Seismic Walkdown Checklist (SWC)

Equipment ID No. 1-1555-A7-015 Equip. Class¹² 10

Equipment Description SIS Pump Room Cooler A

Location: Bldg. Aux Floor El. 180' Room, Area RB 15

Equipment ID No. 1-1604-Q5-PCG Equip. Class¹² Z0

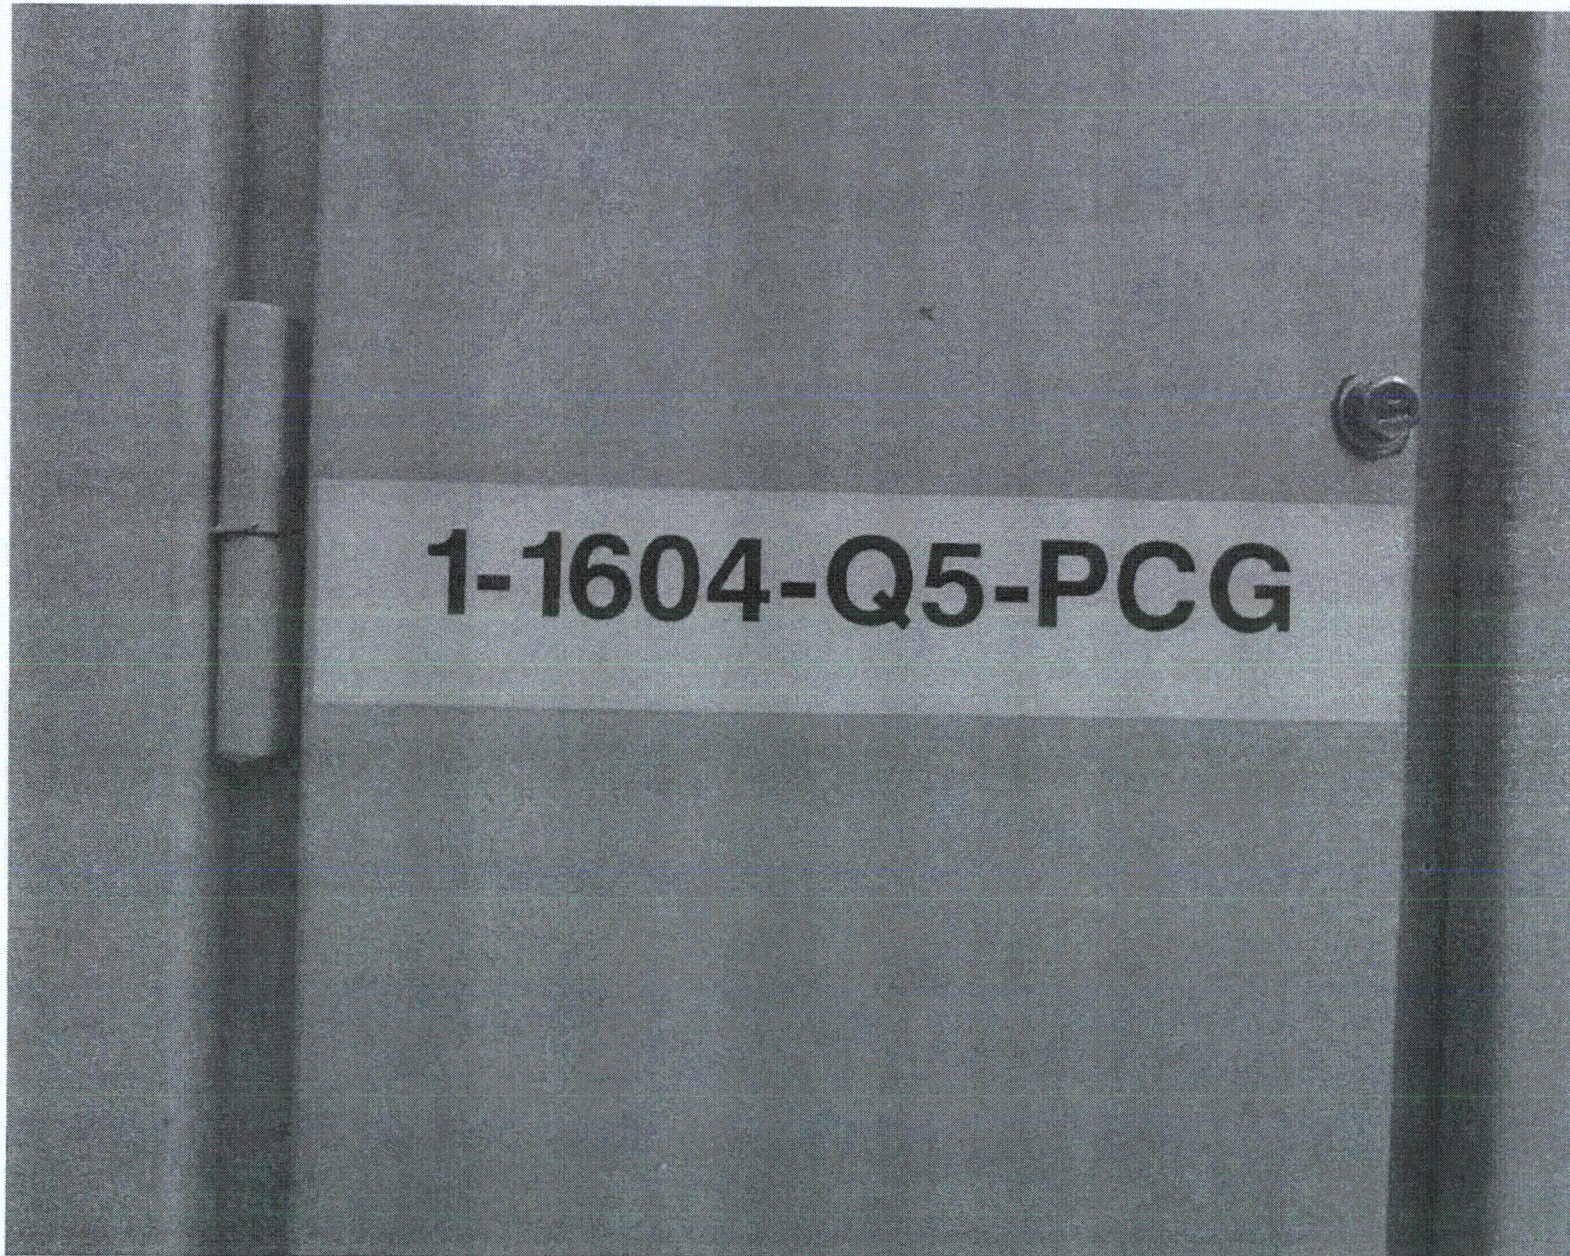
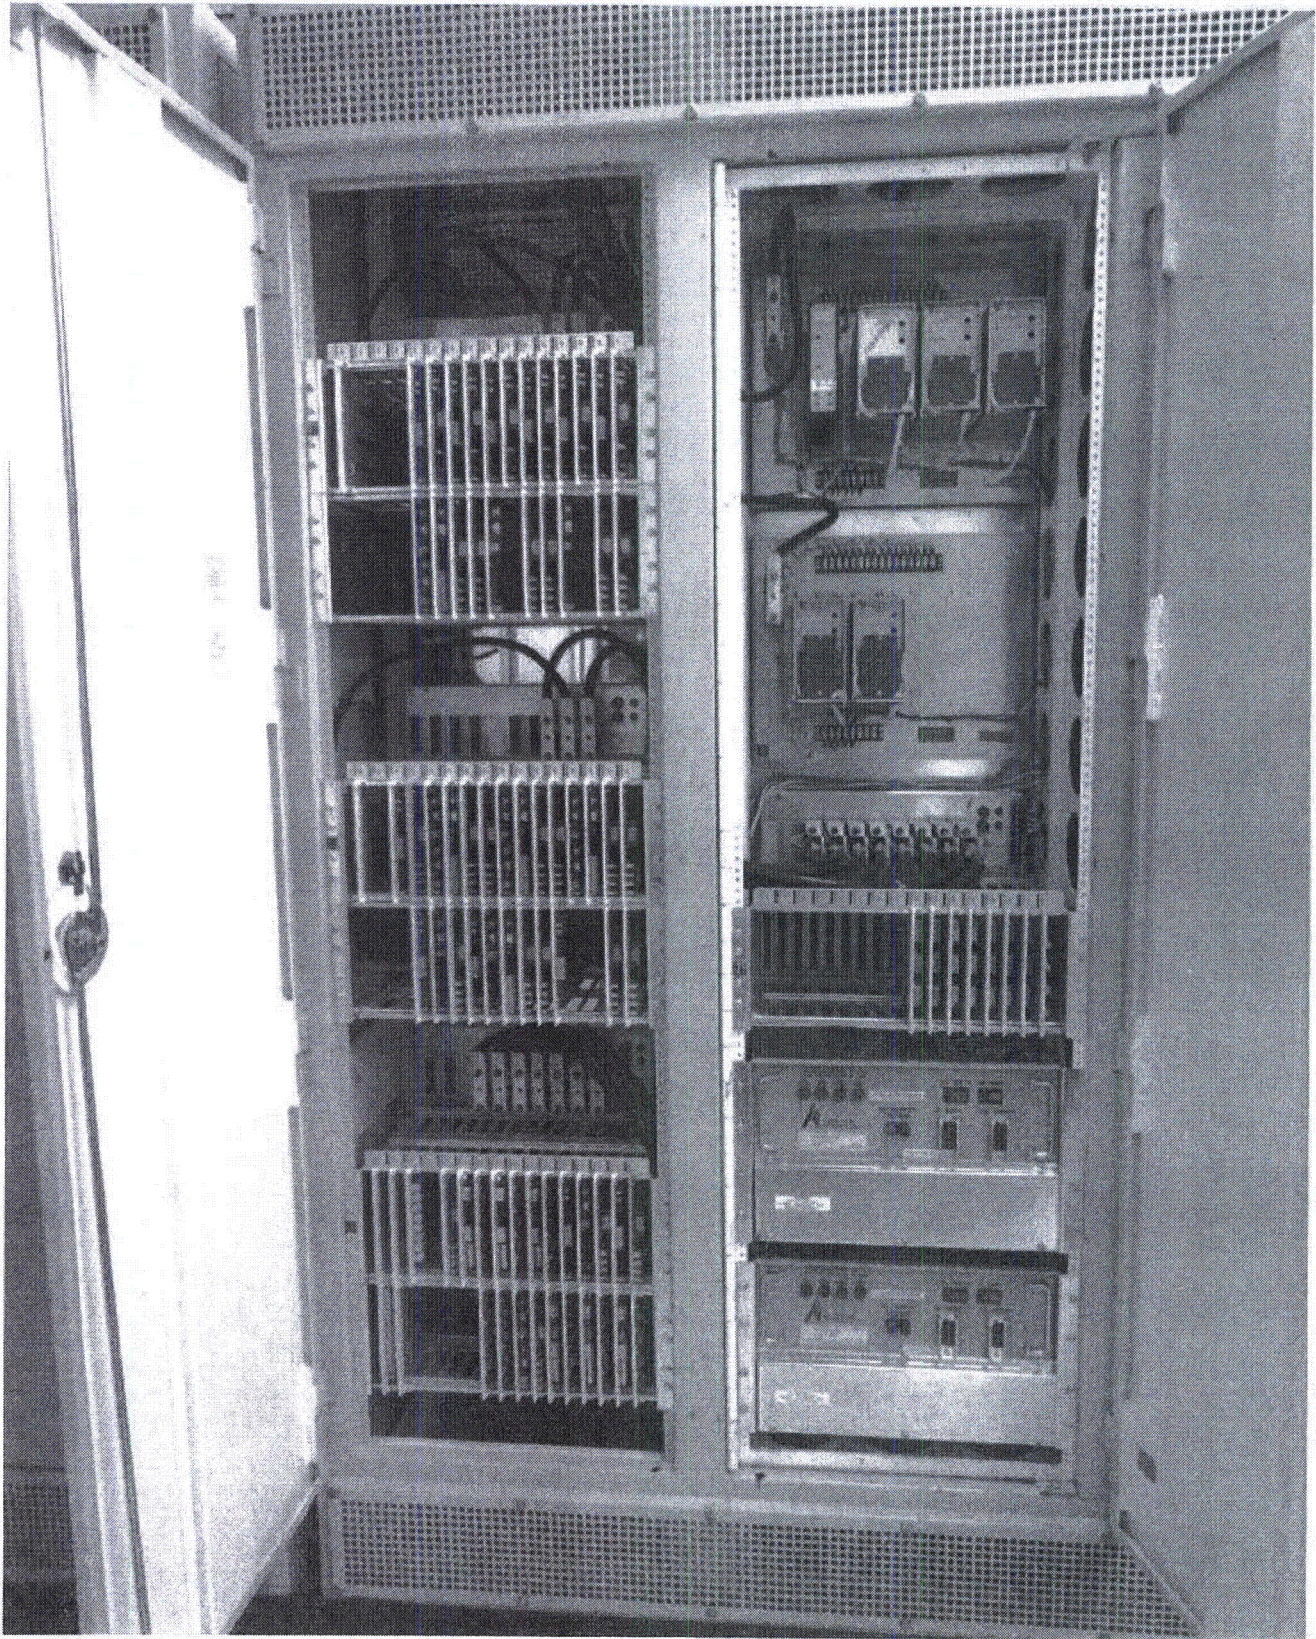
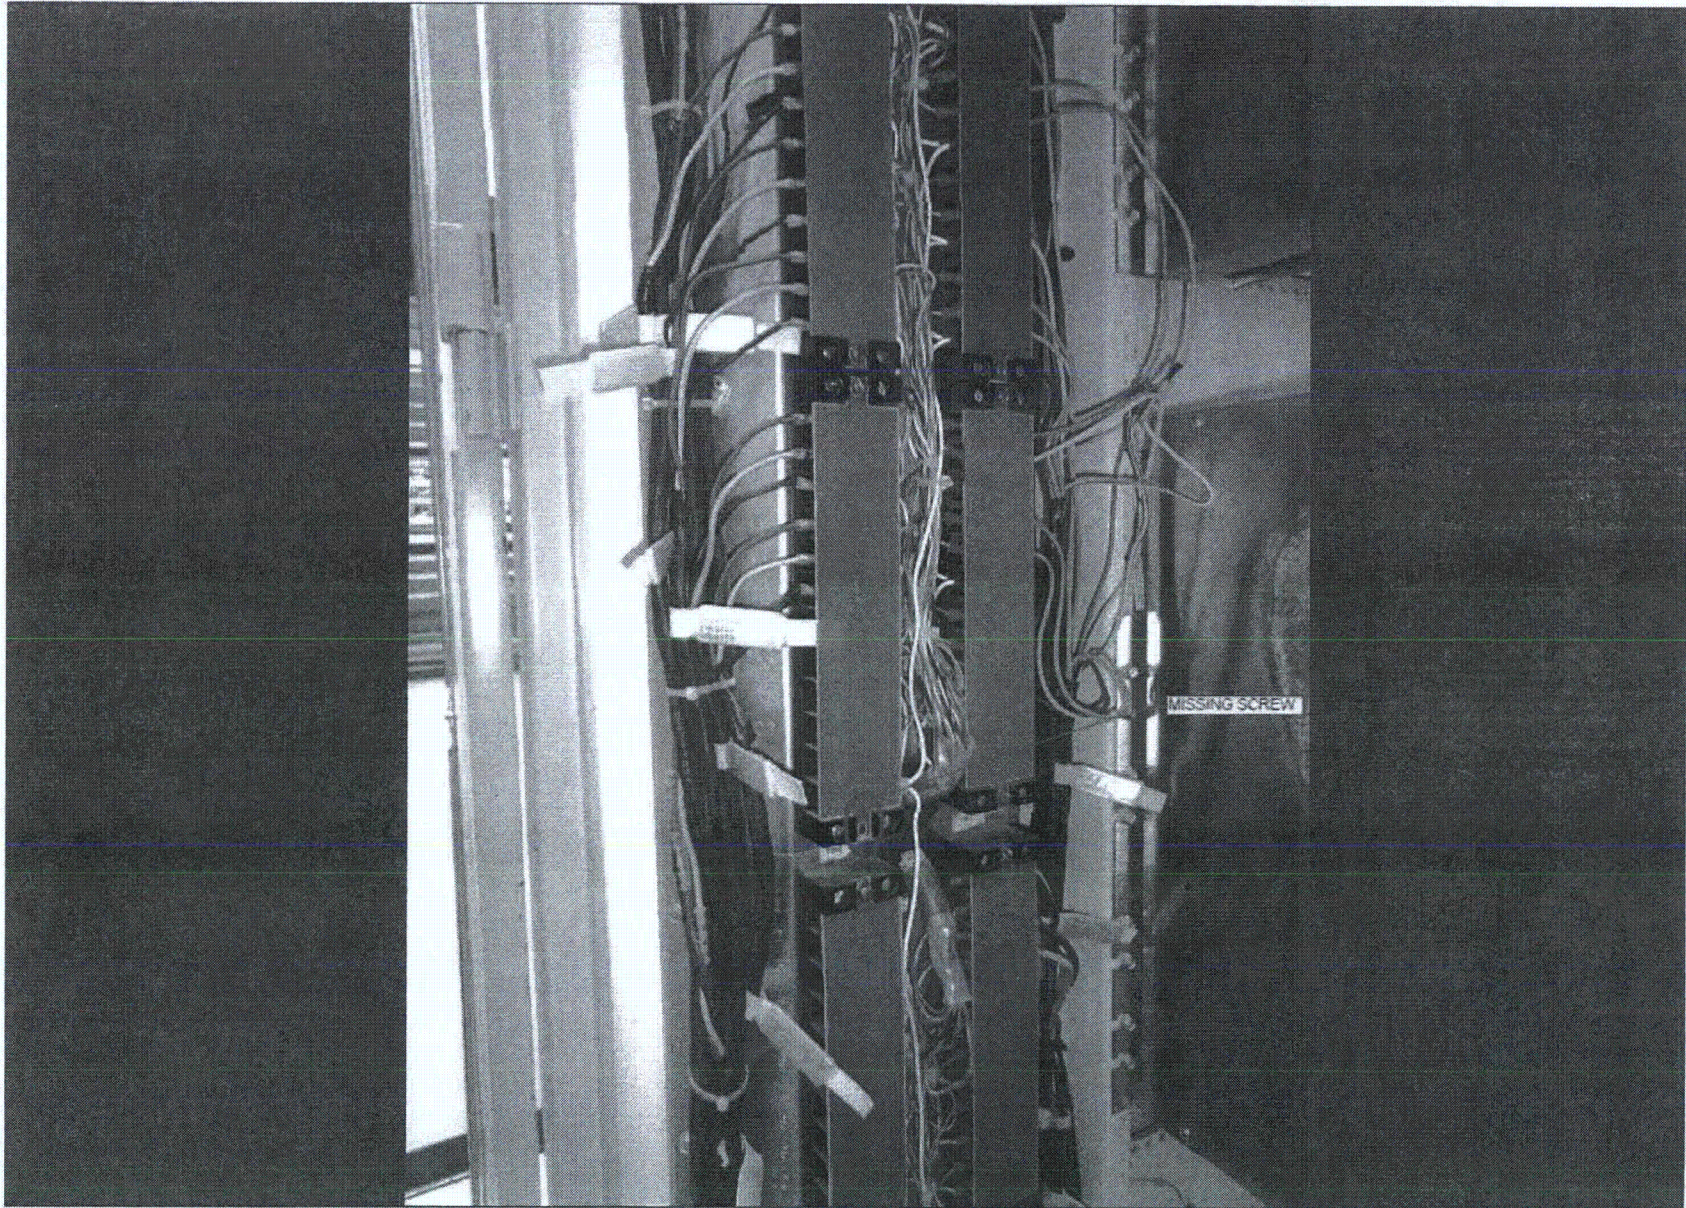
FOUND A SCREW MISSING TO SECURE PROTECTIVE COVER FOR A TERMINAL BLOCK. THE SEISMIC WALKDOWN TEAM JUDGED THAT THIS CONDITION DOES NOT REPRESENT A SEISMIC OR OPERABILITY CONCERN. THIS CONDITION HAS BEEN REPORTED UNDER CR 527624
